ADDENDUM NO. 1

TO PROSPECTIVE BIDDERS UNDER RFQ NO. 1610, "LAFAYETE RECREATION AREA DOCK AND RAMP REPLACEMENT"

C. SPECIFIC REQUIREMENTS (REVISED)

LAFRYCOTE FISHING DOCK

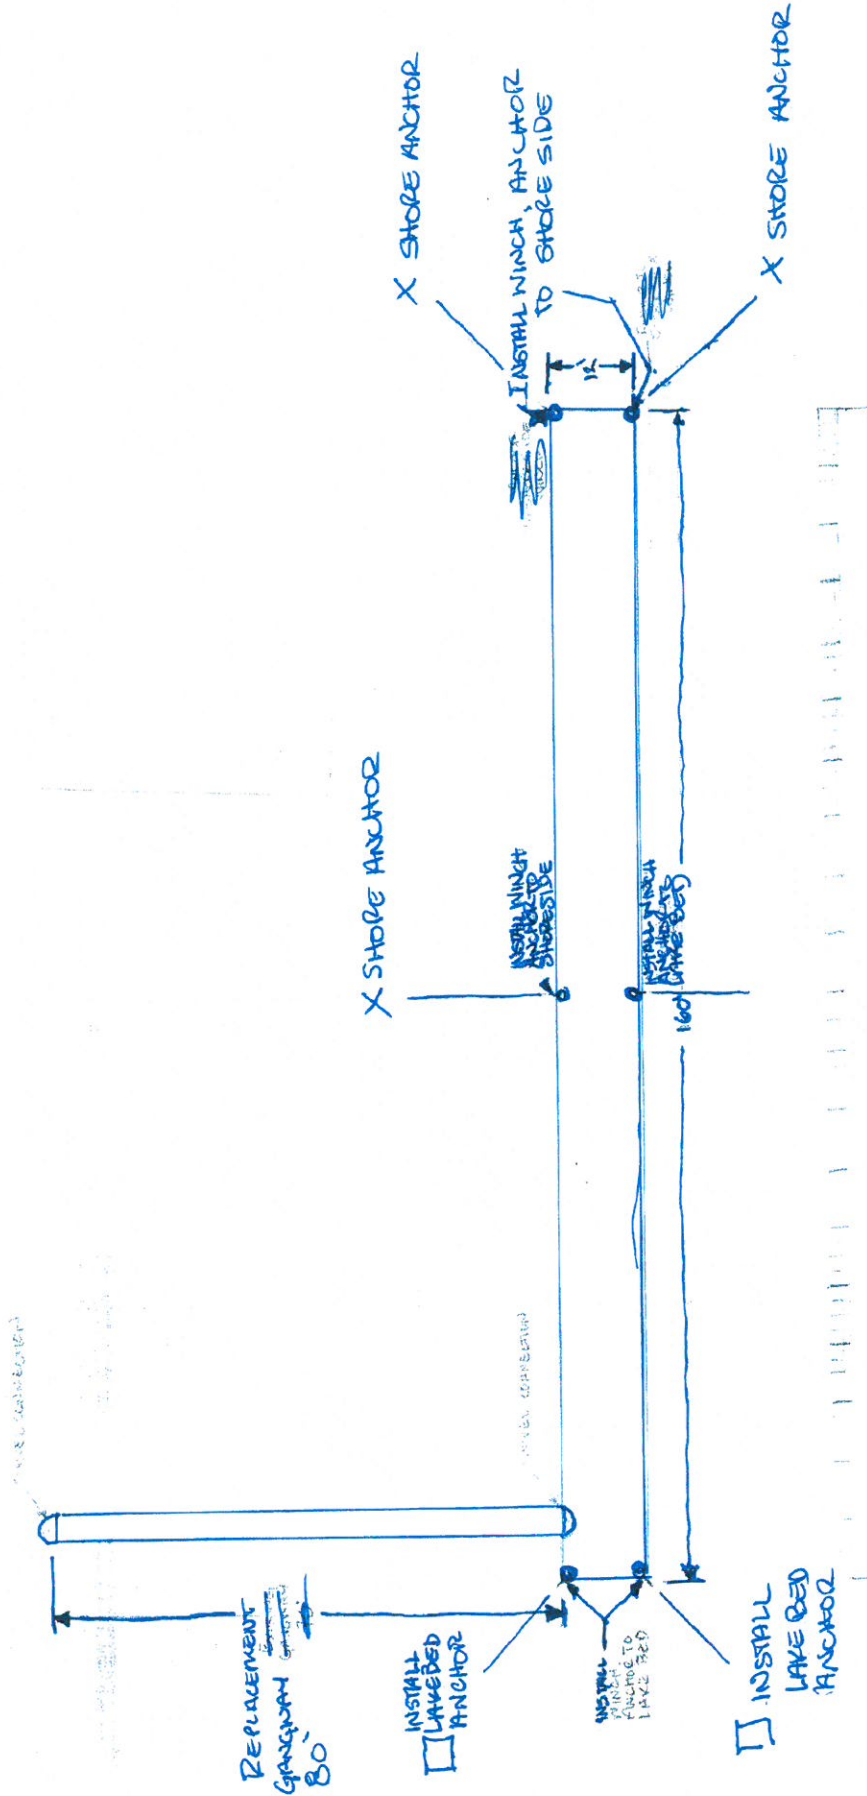
The proposed project is for the demolition and haul away of the existing, deteriorating, dock from its current location. Existing benches attached to the dock surface will be removed and kept on site. This will be followed by the construction and installation of a new dock and gangway in the same location. Dock must include all hardware, hardware connections, gangway abutments, anchor winches, anchor cable, and lake bed anchors.

- The replacement will be a commercial floatation dock measuring 160' long by 12' wide, constructed of standard aluminum fabricate with non-skid decking, ribbed and sandblasted for a non-glare and non-skid finish.

- Railing shall be installed around the entire perimeter of the dock with the exception of where the gangway attaches to the dock. The railing shall be 34" high with vertical balusters spaced no more than 4" apart.

- A 2" high barrier will be installed around the perimeter of the dock surface with the exception of where the railing attaches to the dock.
- Floatation type for the dock and gangway will be 20 psf live load, plus dead load capacity provided with polystyrene foam filled polyethylene tub floatation units. Floatation units will be approved by the Municipality prior to construction.

- A total of six winches will be installed on the dock. Three winches will be attached to dead men on the surrounding shoreline and three will be attached to lake bed anchors that will be placed by the contractor (See drawing for detail.) All winches will attach to anchors using 3/8" stainless steel cable.

- A new gangway should be included in the scope of work. The new gangway will be 80' long and tread will be 42" wide. Gangway will be constructed of the same material as the main dock, including non-skid decking. Railing will be 42" high with vertical balusters spaced no more than 4" apart. Existing abutment will be removed and replaced with new ADA accessible abutment hardware.

- The gangway will attach to the same location as on the existing dock.
